10/574,858

Office Action Summary	Application No. 10/574,858	Applicant(s) NAKANO ET AL.	
	Examiner FRANCIS GARCIA	Art Unit 4185

DETAILED ACTION

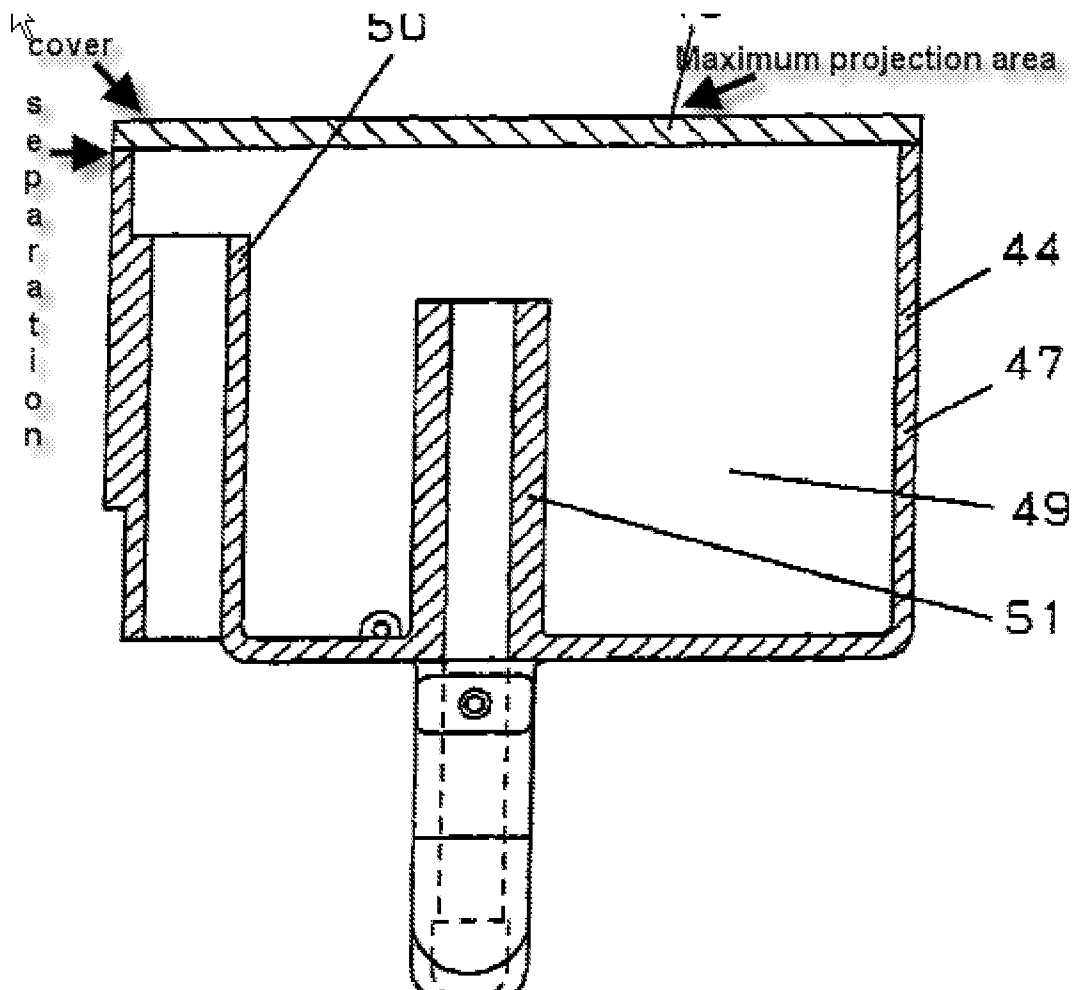
4. **Regarding claim 7**, Osaka discloses a hermetic compressor, wherein among a plurality of walls constituting said casing, a plate thickness of the wall in which the maximum projection area is obtained is thicker than plate thicknesses of the other plate thicknesses [Fig 3 attached on page 11].

6. **Regarding claim 11**, Osaka discloses a hermetic compressor, wherein a **lubricating oil** [46] is stored in said hermetic vessel, and at least one of walls of said casing of said suction muffler to which said lubricating oil is supplied is designed so as to have at least one of a configuration that it is thicker than the other walls of said casing and a configuration that it is higher in foaming magnification [Fig 3 on page 11].

7. **Regarding claim 12**, Osaka discloses a hermetic compressor, wherein the casing of said suction muffler has a suction muffler body and a **suction muffler cover** [48], and wherein a bonding portion between said suction muffler body and said suction muffler cover has a foaming magnification which is relatively lower as compared with portions except said-bonding portion, or it is not foam-molded [Fig 3 attached on page 11].
